LAND AT GREVATT'S LANE, CLIMPING STAGE 1 RSA – DESIGNER'S RESPONSE

LAND AT GREVATT'S LANE, CLIMPING

Stage 1 RSA – Designer's Response

**Land to the South of Grevatt's Lane, Climping.
Proposed Highway Works**

ACHIEVABLE FORWARD VISIBILITY
IN ACCORDANCE WITH SPEED LIMIT
ALONG GREVATT'S LANE

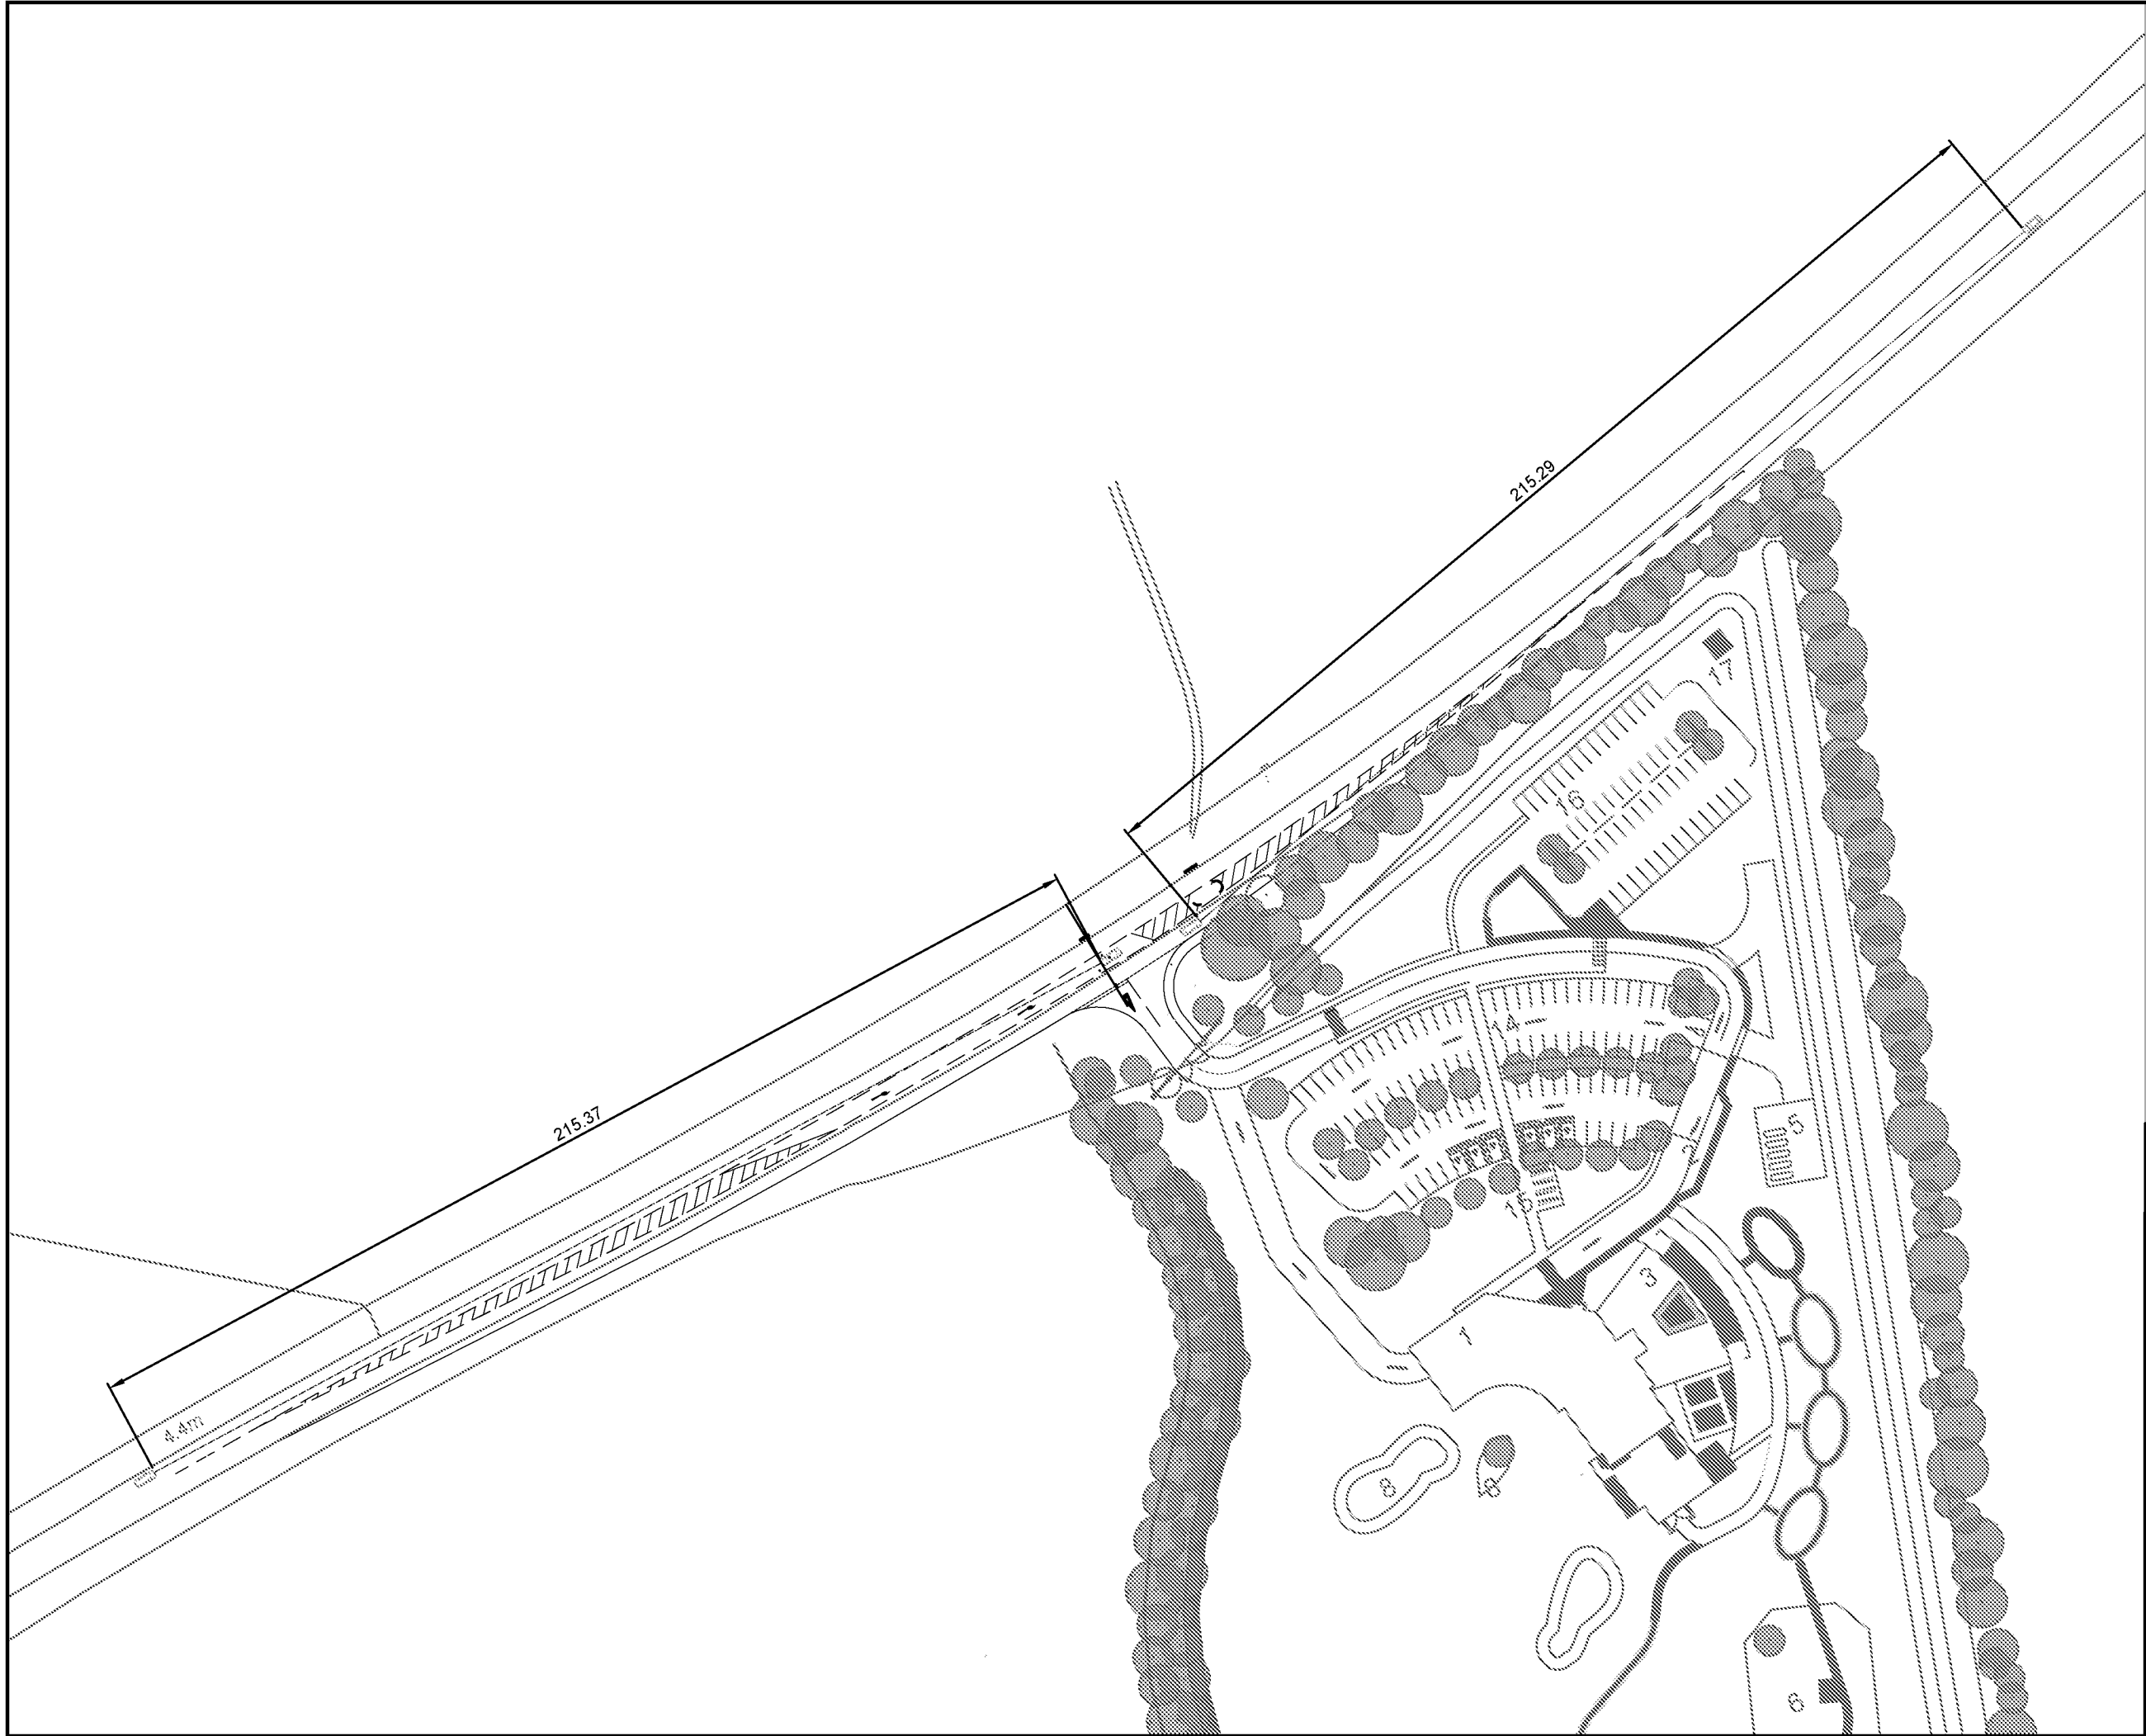
No forward visibility is shown on the drawings. Lack of sufficient forward visibility can lead to late-braking decisions, skidding, and loss-of-control type incidents including collisions with turning traffic.

It is recommended that appropriate forward visibility provided.

- 2.3.1 A drawing has been provided to demonstrate forward visibility along Grevatt's Lane to a vehicle turning left into the site and waiting to turn right into the site, which demonstrates maximum achievable forward visibility of over 470m in each direction within the highway boundary. A second drawing has also been prepared to demonstrate visibility in accordance with the speed limit of 60mph (215m). These drawings (BWREDE-SK03-P2 and BWREDE-SK04-P2) are included as **Appendix C**.

SITE:	GREVATTS LANE WEST SUSSEX. BN17 5RX		
TITLE:	CLIMPING CREMATORIUM		
SCALE AT A3:	DATE:	DRAWN:	CHECKED:
1:500	04-12-2018	ML	
DRAWING NO:	SC-CLMPG-V1-XX-DR-K-0500		REVISION: D

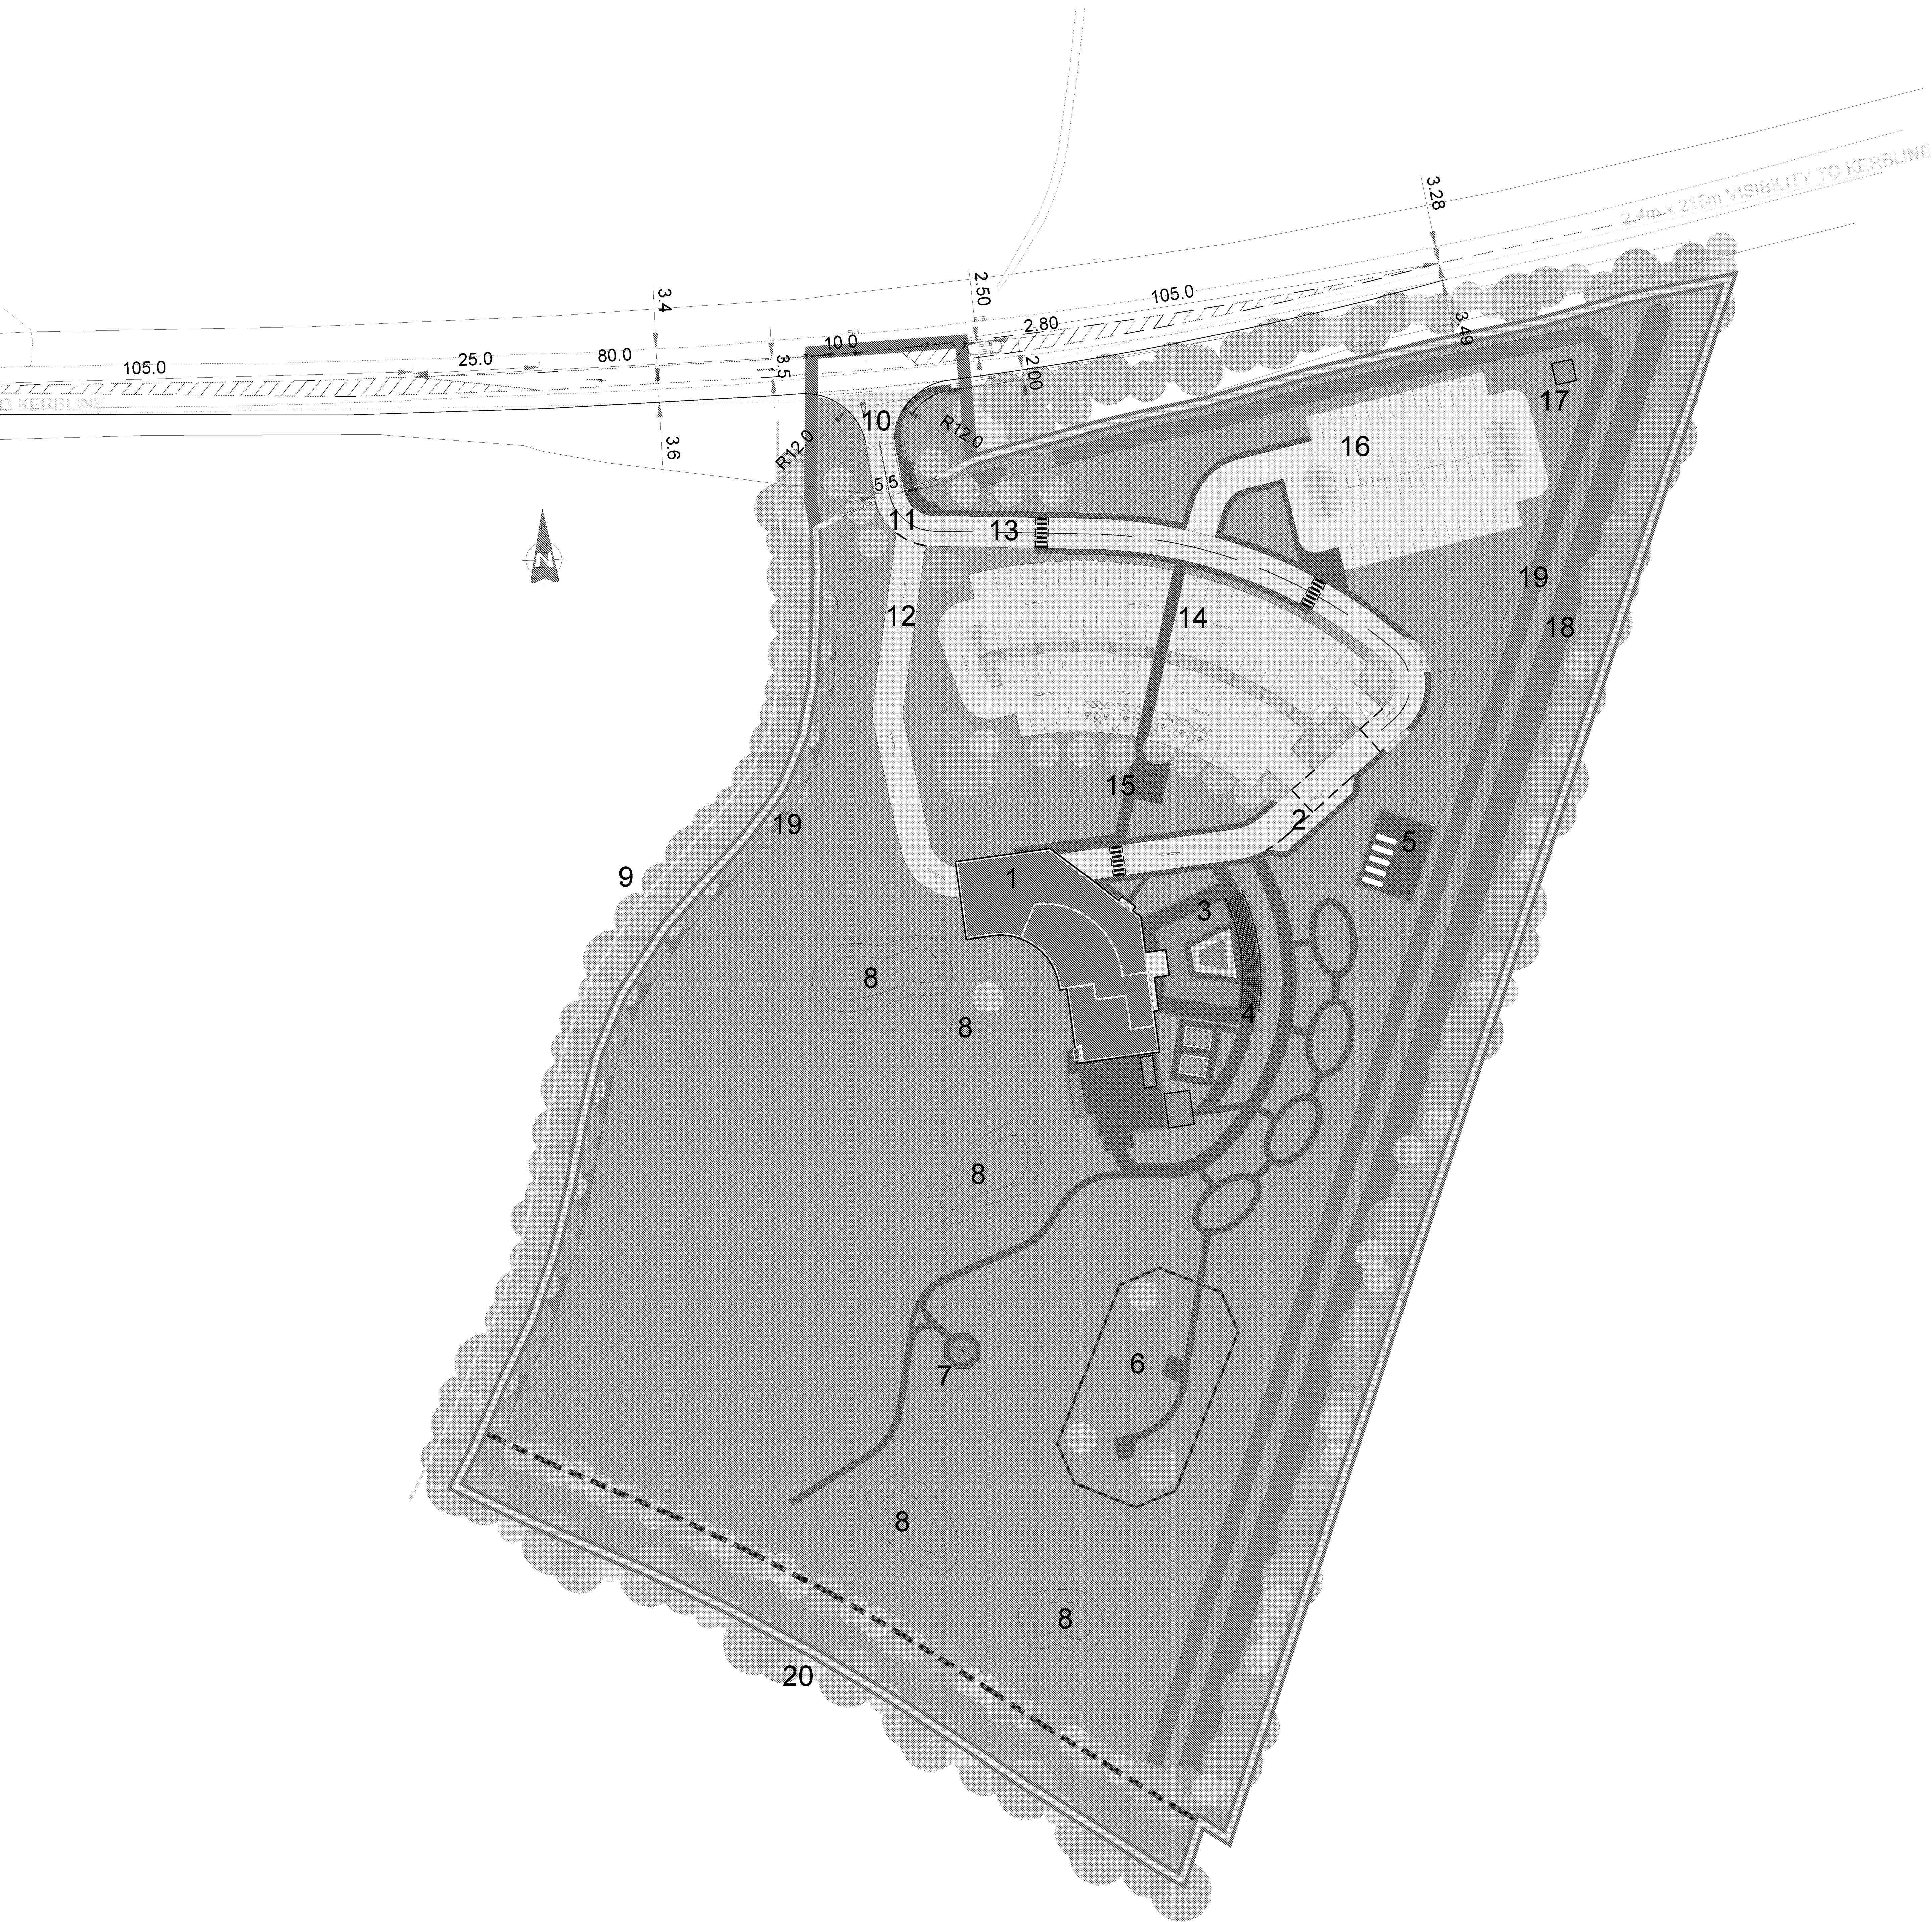
The oblique alignment of the proposed junction can create difficulties for some drivers, particularly the elderly, as this required them to look over their shoulder, when they may be suffering from restricted neck movement. There is a risk of damage-type collisions between egressing vehicles.

It is recommended that the proposed internal car park access junction is aligned to provide a more conventional perpendicular junction arrangement.

- 2.5.1 The internal site layout has been revised to demonstrate the internal car park junction alignment to be perpendicular to the carriageway to allow for ease of visibility. The revised site plan is contained as **Appendix D**.
